Highway 17/417 Twinning The 'Value' of Partnerships

CSVA – October 23, 2006

Key “Accepted” Recommendation

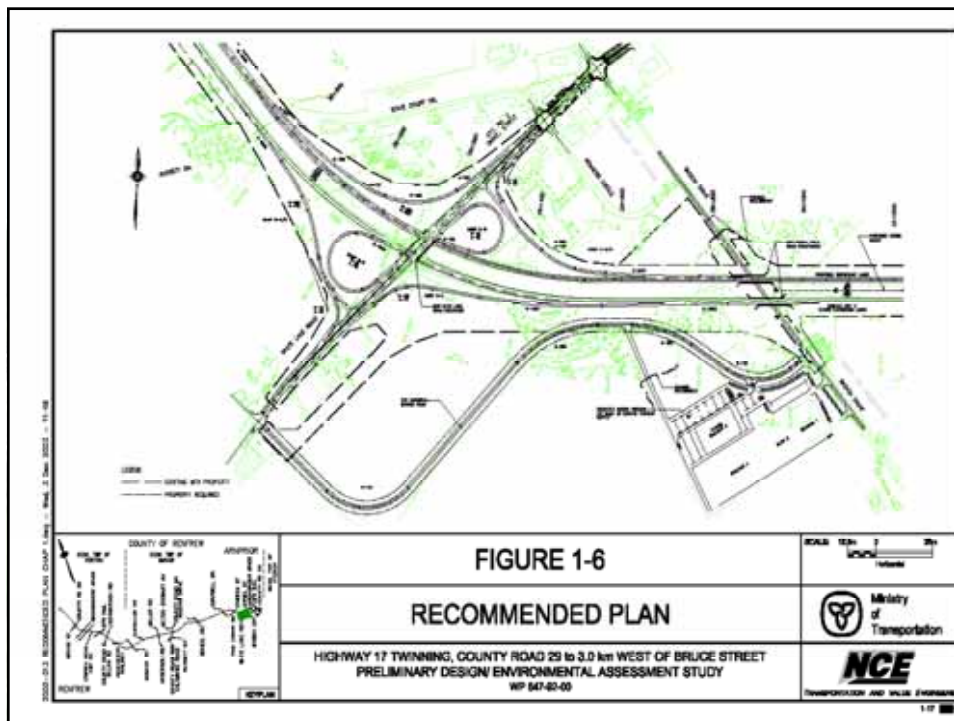
- Revise South Service Road Alignment to Baskin Drive (Win – Win – Win – Win Scenario)

Did we re-open the Approved TESR to get to Win-Win Win?

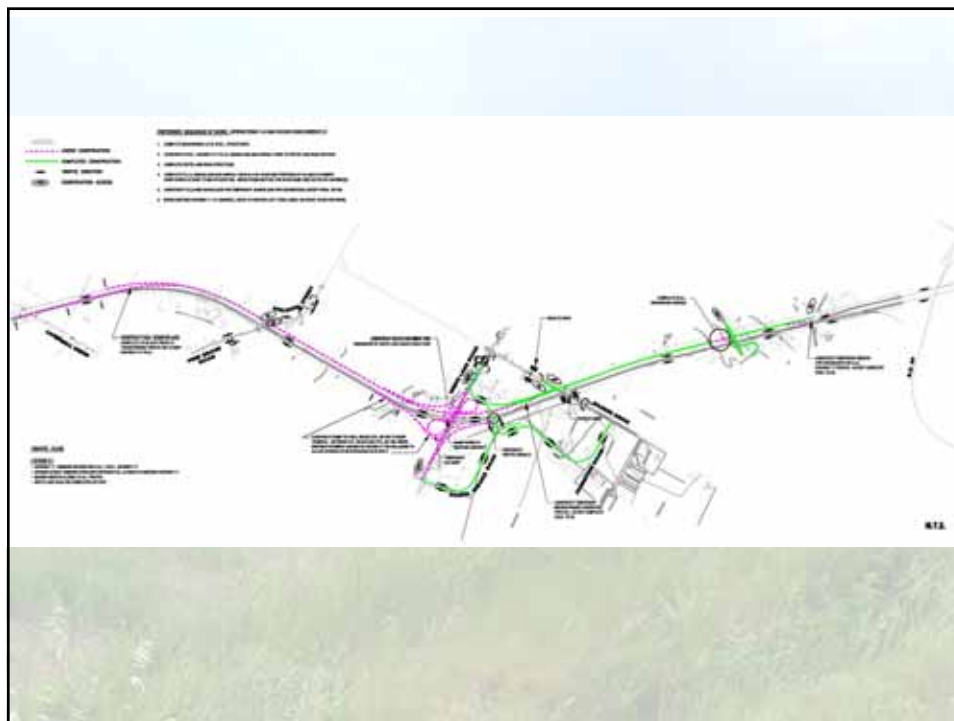
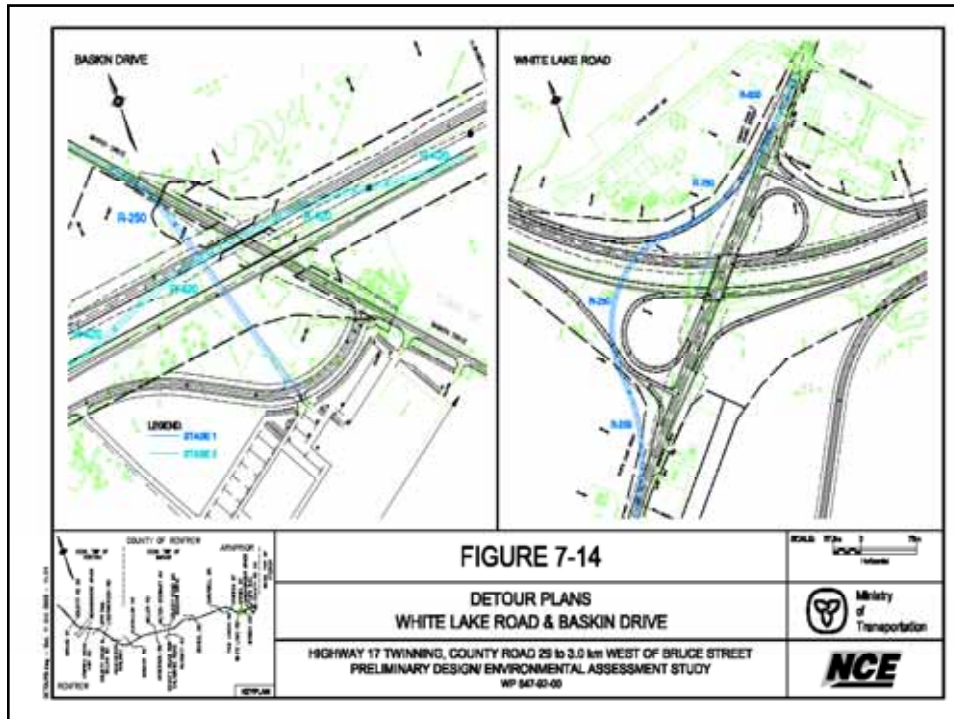
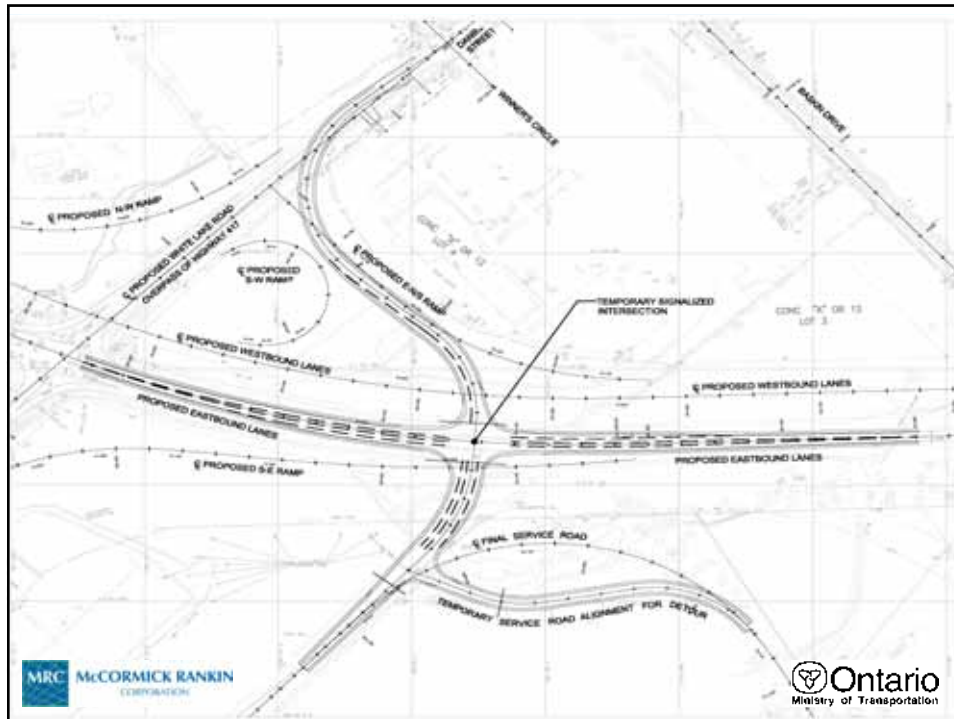
- Yes, Addendum to TESR regarding realigned South Service Road required and currently being finalized
- All parties were involved in Post VE follow-up including further analyses of other SSR alignments
- VE alignment was further revised to bi-sect PWGC property (VE alignment went more southerly).
- All parties continue to support revised SSR alignment

Improved Design Related

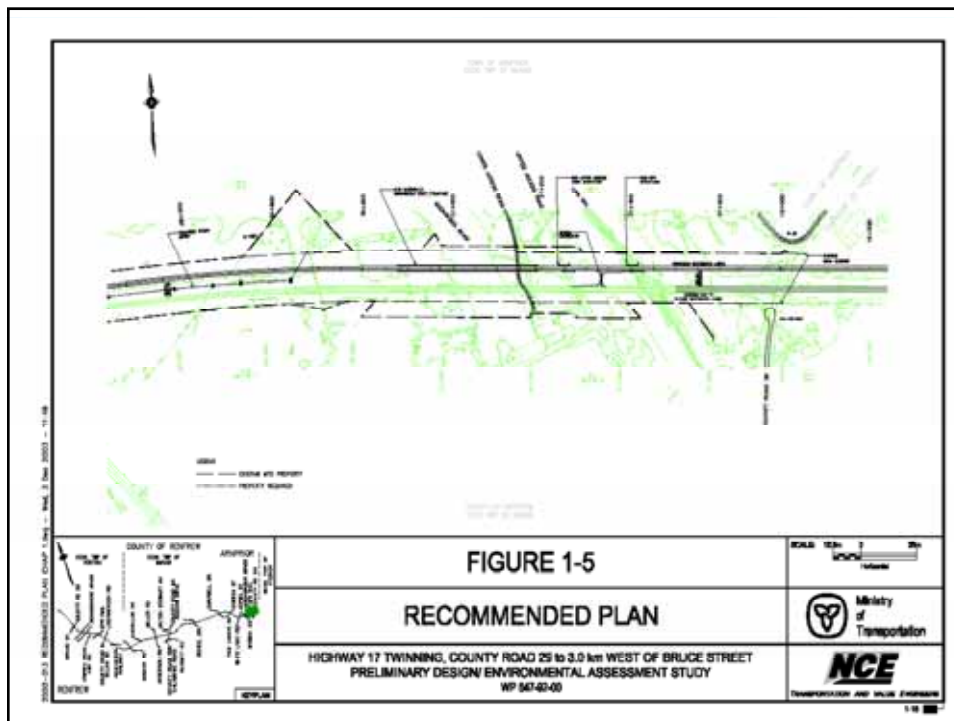
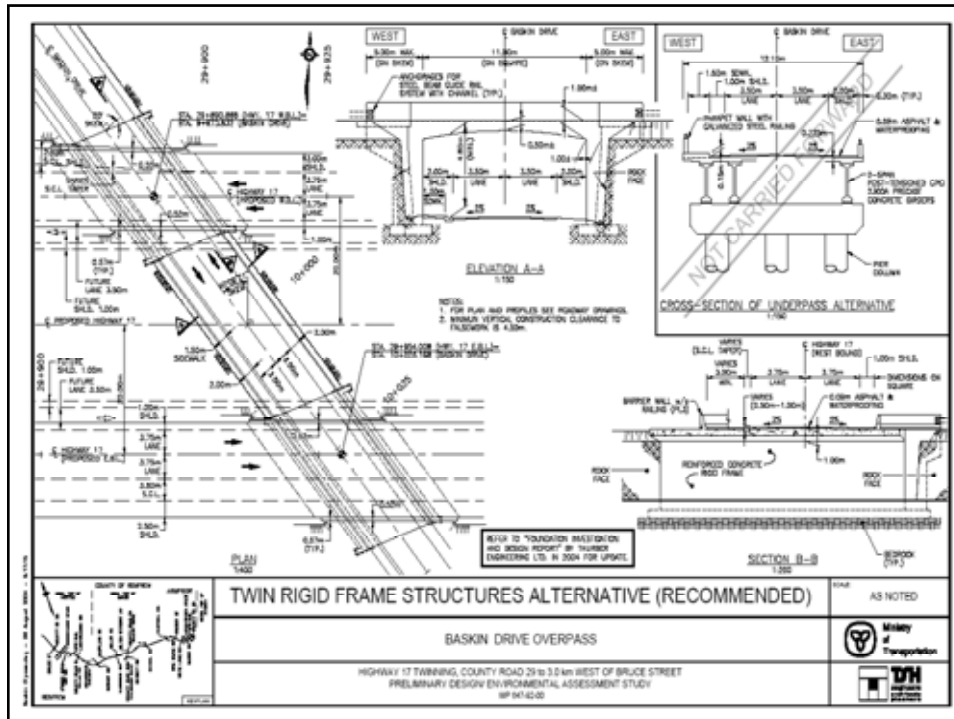
- Defer additional ramps at Co. Rd. 29 interchange (Retain A-2).
- Build Baskin Structures perpendicular to Hwy 417 and add an additional 0.5 m shoulder
- Move ARWIS Tower from median to outside shoulder area (eliminates median turn-around)
